Site Control Modification Manual 14H Update

Jonathan Thompson
Interconnection Projects

Markets and Reliability Committee
March 19, 2025

Exhibit 10: Generator Interconnection into Existing TO Substation

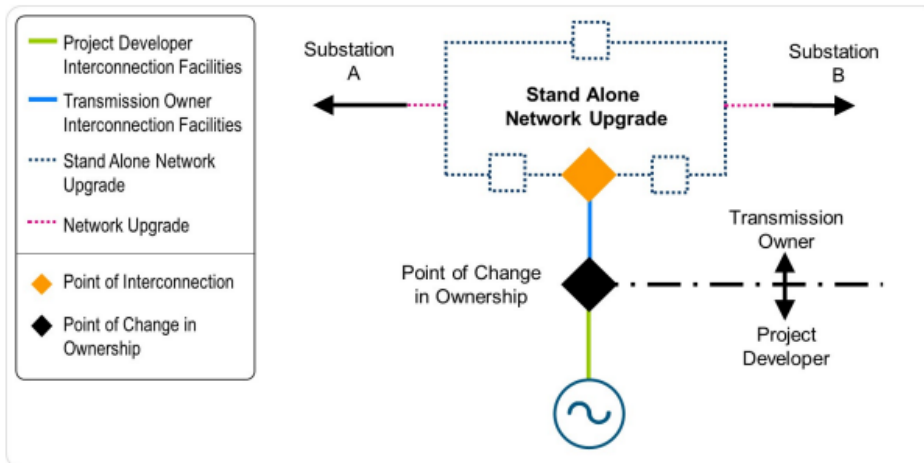
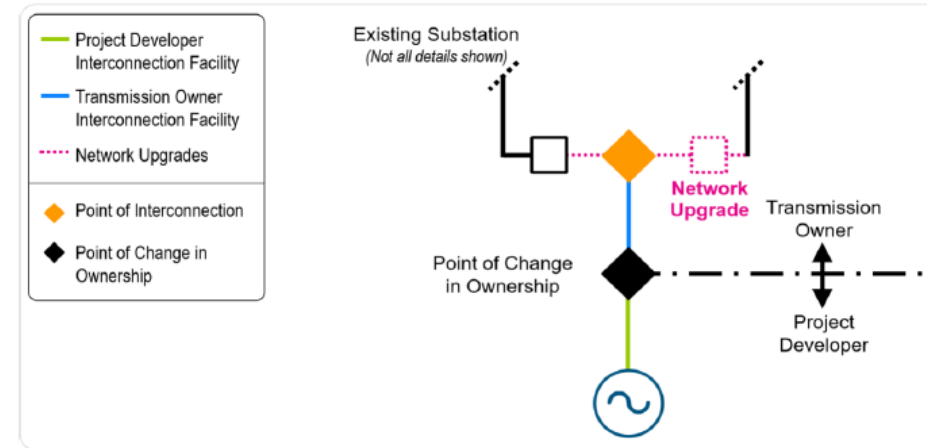
- In M-14H Section 4.9 shows diagrams of typical New Service Request Connection Types
- Exhibit 9 shows “Generator Interconnection via New Interconnection Switchyard”
- Exhibit 10 is supposed to show “Generator Interconnection into Existing TO Substation” but instead is the same diagram used in Exhibit 9

- PJM seeks to correct Exhibit 10
- PJM seeks to provide greater clarification on how Developers can meet tariff requirements for Site Control and what Site modifications are allowed under the tariff
- As PJM continues progress through TC1 and TC2 applications are due in Q4 2024, it is important for Developers to understand what Site Control modifications are allowed under the tariff in order to be able to continue to develop their projects and meet tariff requirements for Site Control at various points of the Interconnection Cycle process
